Town of Clifton Park Planning Board
One Town Hall Plaza
Clifton Park, New York 12065
(518) 371-6054 FAX (518)371-1136

Planning Board Minutes
March 23rd, 2021

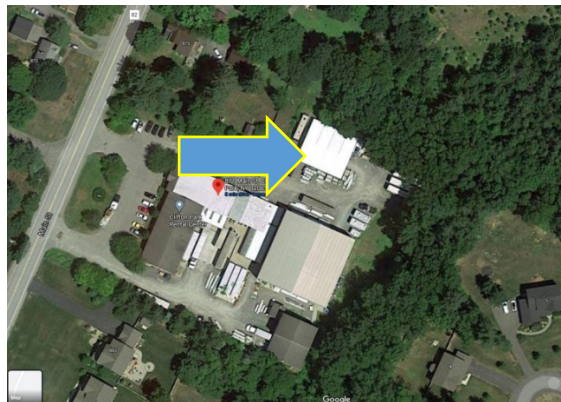
1. Since Main Street is a County Road a referral to the Saratoga County Planning Board for a recommendation on this proposal is required.
2. The applicant should meet with Steve Myers, Chief Zoning Officer to determine setback requirements.
3. It is understood that the approximate location of the proposed pole barn is in the general footprint (slightly larger) for where a tent canopy structure was previously shown per the aerial image below.
